Point Beach Nuclear Plant, Units 1 and 2
Dockets 50-266 and 50-301
Renewed License Nos. DPR-24 and DPR-27

License Amendment Request 261
Extended Power Uprate
Response to Request for Additional Information

LICENSE AMENDMENT REQUEST 261 EXTENDED POWER UPRATE RESPONSE TO REQUEST FOR ADDITIONAL INFORMATION

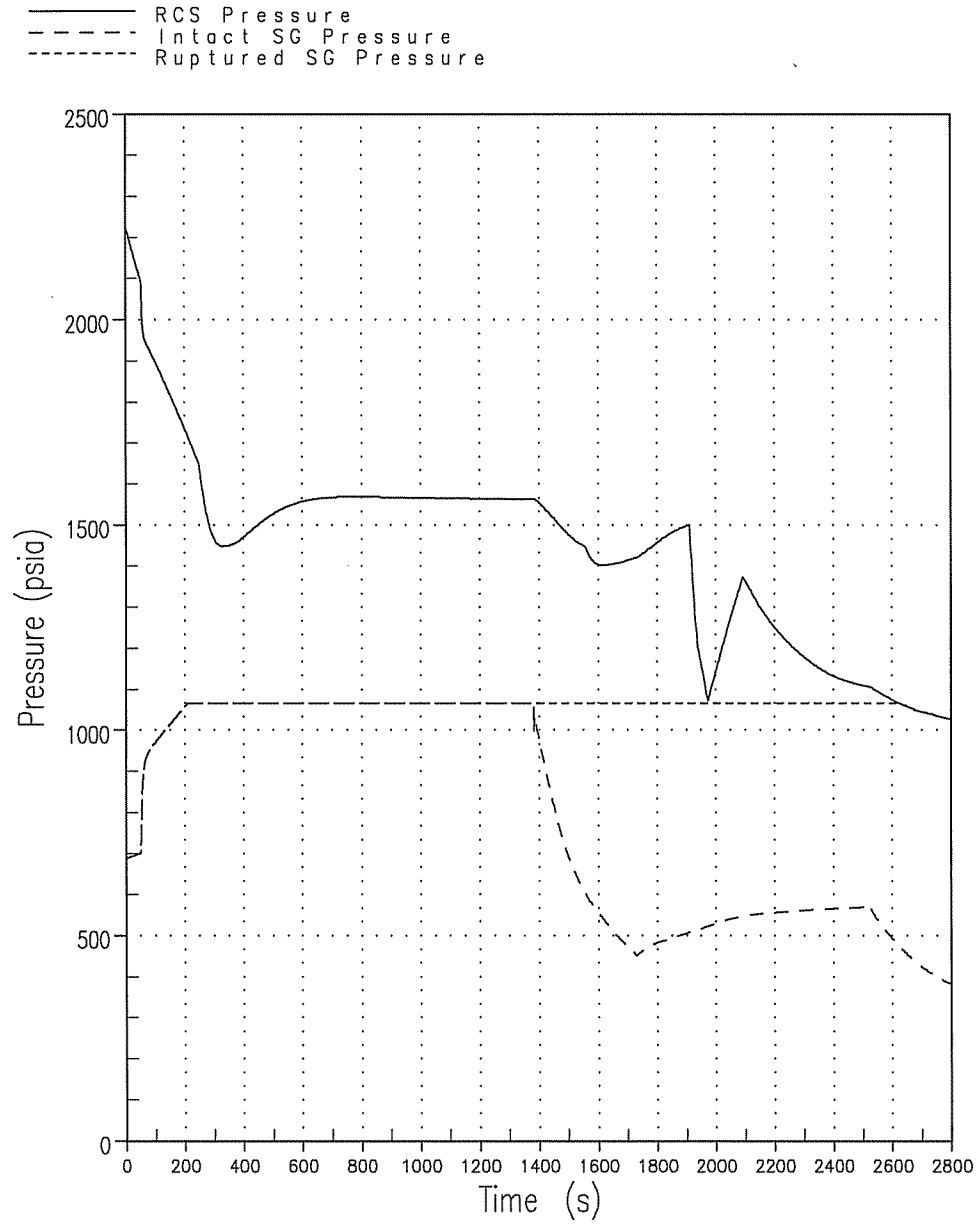
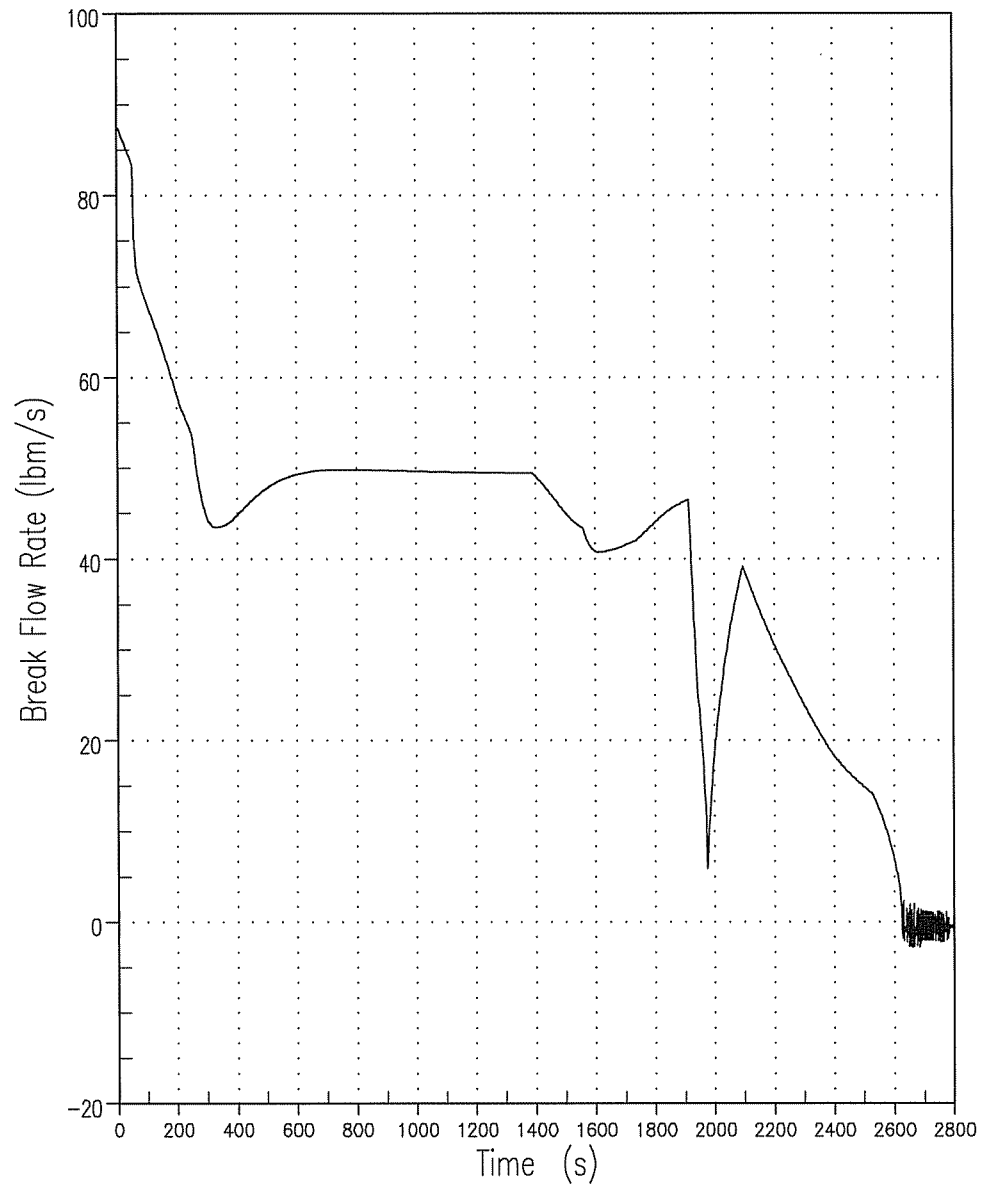
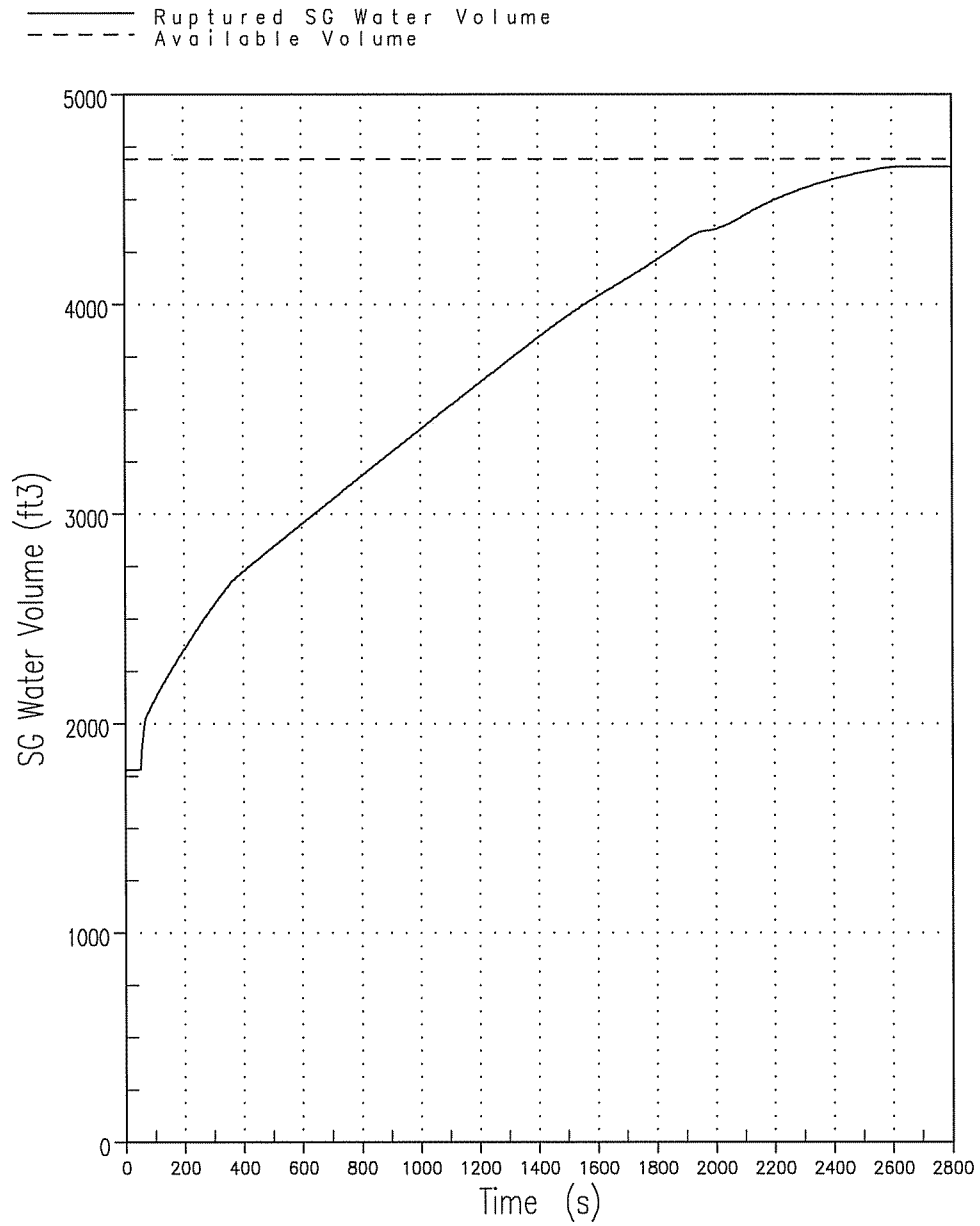
Provide a thermal-hydraulic analysis for PBNP, at both current licensed thermal power conditions and at the proposed, uprated conditions, for a limiting margin-to-overfill/overfill scenario. One acceptable methodology would be for the analysis to align as closely as possible to what is approved in WCAP-10698-P-A; however, since the licensee has asserted that a limiting single failure is not in the Point Beach licensing basis, this exception to the WCAP-10698-P-A methodology would be acceptable.

The results indicate a margin to overfill of $>30 \text{ ft}^3$ in the ruptured steam generator (SG) for the CLTP case, and $>70 \text{ ft}^3$ in the ruptured steam generator for the EPU case. No water is transferred into the steam lines. The sequence of events for each analysis is provided in Table 2. Figures 1, 2, and 3 provide the time-dependent primary and secondary pressures, primary-to-secondary break flow, and ruptured steam generator water volume, respectively, for

the limiting CLTP scenario. Figures 4, 5, and 6 provide the same figures for the limiting EPU scenario.
